Identification cards — Test methods —

Proximity cards

**AMENDMENT 4: Additional test methods for
PCD RF interface and PICC alternating field
exposure**

Amendment 4 to ISO/IEC 10373-6:2001 was prepared by Joint Technical Committee ISO/IEC JTC 1, *Information technology*, Subcommittee SC 17, *Cards and personal identification*.

Figure 1 — ESD test circuit

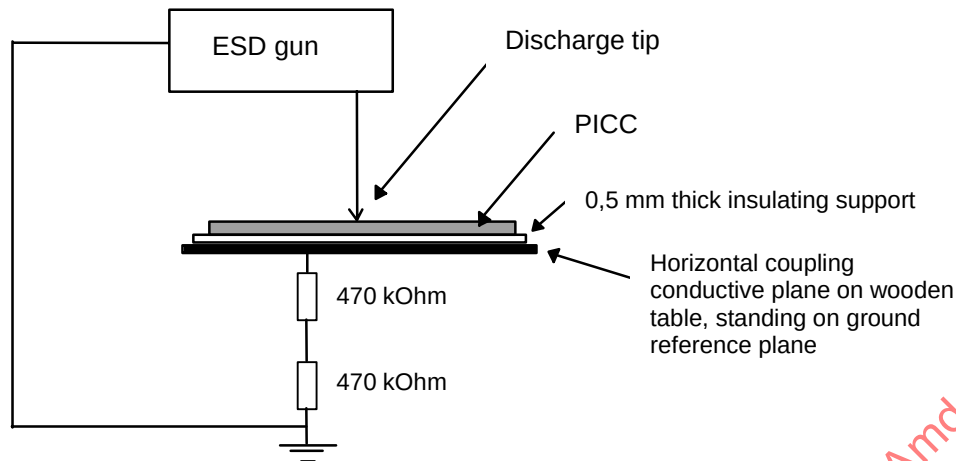
Replace Clause 5 and subclauses 5.1, 5.2 and 5.3 with the following:

The purpose of this test is to check the behaviour of the card IC in relation to electrostatic discharge (ESD) exposure in the test sample. The PICC under test is exposed to a simulated electrostatic discharge (ESD, human body model) and its basic operation checked following the exposure.

5.3.1 Apparatus

Refer to IEC 61000-4-2:1995.

a) Main specifications of the ESD generator:

- energy storage capacitance: $150 \text{ pF} \pm 10 \%$;
- discharge resistance: $330 \Omega \pm 10 \%$;
- charging resistance: between $50 \text{ M}\Omega$ and $100 \text{ M}\Omega$;
- rise time: $0,7 \text{ ns}$ to 1 ns .

Figure 2 — Test zones on PICC for ESD test

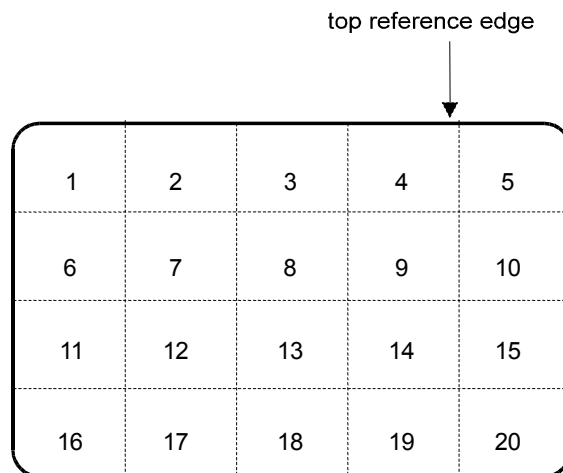
Apply the discharge successively in normal polarity to each of the 20 test zones shown in Figure 2. Then repeat the same procedure with reversed polarity. Allow a cool-down period between successive pulses of at least 10 s .

WARNING — If the PICC includes contacts, the contacts should face up and the zone which includes contacts should not be exposed to this discharge.

Check that the PICC operates as intended at the end of the test.
